Work Order ID 149175

Item Name: Heli-Access Step, Short, High Gear

DART SERVICE INSTRUCTION

TO AMEND INSTALLATION INSTRUCTIONS D350-591 REV. G
AND INSTRUCTIONS FOR CONTINUED AIRWORTHINESS ICA-D350-591 REV. 3
REF TCCA STC: SH92-6
REF FAA STC: SH967NE

FIGURE 32-9: Crosstube Attachment

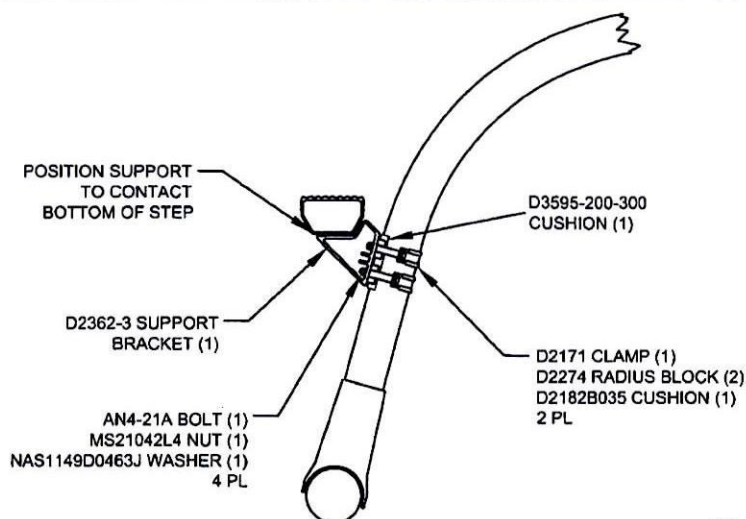
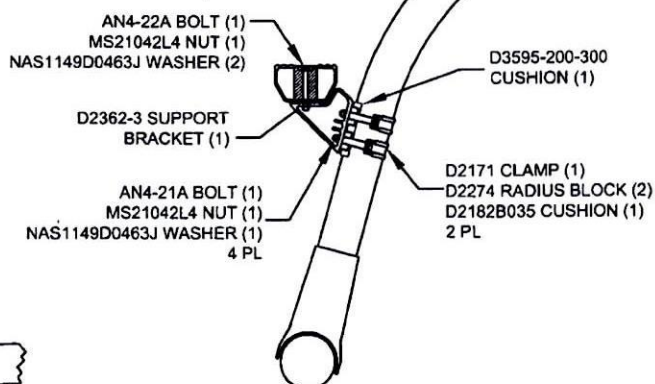
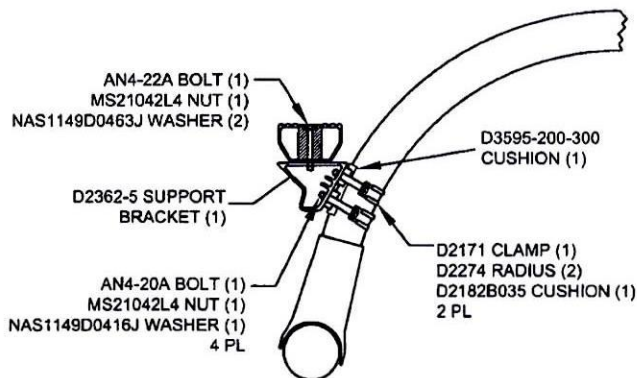
TO PROVIDE AN OPTIONAL CUSHION KIT TO BE INSTALLED ON THE D350-591-111A/-113/-115/-117A/-119 *Heli-Access-Step*™ (THE D2856-400-720 ABRASION STRIP IS REPLACED WITH THE D3595-200-300 CUSHION).

FOR D350-591-111A/-113/-115 @ CHG 005 (OR LATER), D350-591-117A @ CHG 003 (OR LATER) AND D350-591-119 @ CHG 004 (OR LATER), THE PARTS LIST OF INSTALLATION INSTRUCTIONS D350-591 AND INSTRUCTIONS FOR CONTINUED AIRWORTHINESS ICA-D350-591 IS AMENDED AS FOLLOWS:

1. REMOVE THE STEP PER ICA-D350-591 SECTION 32.2
2. REMOVE THE D2856-400-720 ABRASION STRIP PER ICA-D350-591 SECTION 32.4
3. POSITION THE D3595-200-300 CUSHION AS INDICATED ON SHEET 3 OR 4 (AS APPLICABLE) OF THIS SERVICE INSTRUCTION.
4. REINSTALL THE STEP PER ICA-D350-591 SECTION 32.1 AS APPLICABLE USING THE NEW HARDWARE PROVIDED AS SHOWN ON SHEET 3 OR 4 (AS APPLICABLE) OF THIS SERVICE INSTRUCTION.
